JOINT REGIONAL PLANNING PANEL
(Sydney Region East)

JRPP No	2013SYE090
DA Number	394/2013
Local Government Area	City of Canada Bay
Proposed Development	Demolition, remediation and construction of four residential flat buildings containing 152 units and 219 car parking spaces
Street Address	186 Great North Road, Five Dock
Applicant	EG Funds Management C/- SJB Planning
Owner	EG Funds Management
Cost of Works	\$50,050,000
Number of Submissions	Twenty five (25)
Recommendation	Approval subject to Conditions
Report by	Mr Stuart Ardlie – Senior Statutory Planner, City of Canada Bay

View from sun - Midwinter

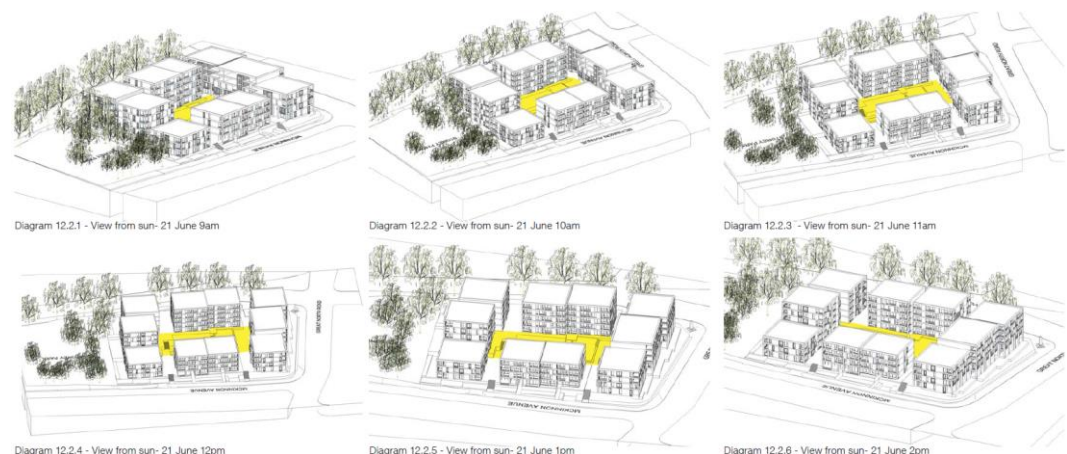
The applicant has submitted a view from the sun diagrams (refer below) which demonstrate the building massing and terracing of the central landscaped areas, will result in more than three hours of solar access to a substantial portion of the central communal open space area in midwinter.

During midwinter the site will cast shadow onto Great North Road and Lyons Road in the morning, Lyons Road at midday and Lyons Road and a small portion of Storey Park in the afternoon. Based on this assessment the proposal will provide compliant solar access with minimal to nil overshadowing of the neighbouring residential properties.
